Access Compliance Report

Public Rights-of-Way

(Pedestrian Signals)

Intersection ID: N/A	Main Street:	Cross Street: N/A	Location: N/A
ADA ID: 89B2EFC513AF	Signal Type: One Push Button-APS	Overall Compliance: No	Severity Score: BTN 1: N/A BTN 2: N/A No BTN: N/A
Codes/Mitigation Info/Possible Solution		Field Measurements/Component Compliance

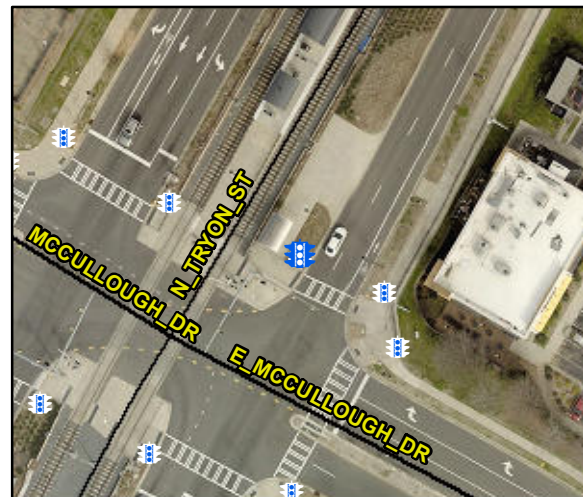
Possible Solutions: Replace Signal Push Button With APS Button on New Post. Remove & Relocate Sign.

PROW/ADA: TMUTCD 4e.08, R404.7.3, R404.7.2, R209.1, MUTCD 4e.10

N/A	B 1 FWD Approach Width (in)	N/A	N/A	B 2 FWD Approach Width (in)	N/A
N/A	B 1 FWD Approach Obstruction?	Yes	N/A	B 2 FWD Approach Obstruction?	N/A
N/A	B 1 FWD Approach Obstruction Dist (in)	2.0	N/A	B 2 FWD Approach ObstructionDist (in)	N/A
N/A	B 1 PARA Approach?	Yes	N/A	B 2 PARA Approach?	N/A
N/A	B 1 PARA Approach Constrained?	Yes	N/A	B 2 PARA Approach Constrained?	N/A
No	B 1 PARA Approach Reach (in)	16.0	N/A	B 2 PARA Approach Reach (in)	N/A
No	B 1 PARA Approach Width (in)	48.0	N/A	B 2 PARA Approach Width (in)	N/A
N/A	B 1 PARA Approach Obstruction?	Yes	N/A	B 2 PARA Approach Obstruction?	N/A
N/A	B 1 PARA Approach Obstruction Dist (in)	2.0	N/A	B 2 PARA Approach ObstructionDist (in)	N/A
Yes	B 1 Clear Floor Space Slope (%)	0.9	N/A	B 2 Clear Floor Space Slope (%)	N/A
Yes	B 1 Clear Floor Space XSlope (%)	0.5	N/A	B 2 Clear Floor Space XSlope (%)	N/A
N/A	B 1 PAR Slope (%)	N/A	N/A	B 2 PAR Slope (%)	N/A
Yes	B 1 Height (in)	39.0	N/A	B 2 Height (in)	N/A

N/A	B 1 Clear Xing Direction?	Yes	N/A	B 2 Clear Xing Direction?	N/A
	B 1 Crossing Direction	To SE		B 2 Crossing Direction	N/A
Yes	B 1 DistanceTo XWalk (in)	10.0	N/A	B 2 DistanceTo XWalk (in)	N/A
No	B 1 DistanceTo Curb (in)	12.0	N/A	B 2 DistanceTo Curb (in)	N/A
Yes	B 1 Diameter (in)	2.0	N/A	B 2 Diameter (in)	N/A
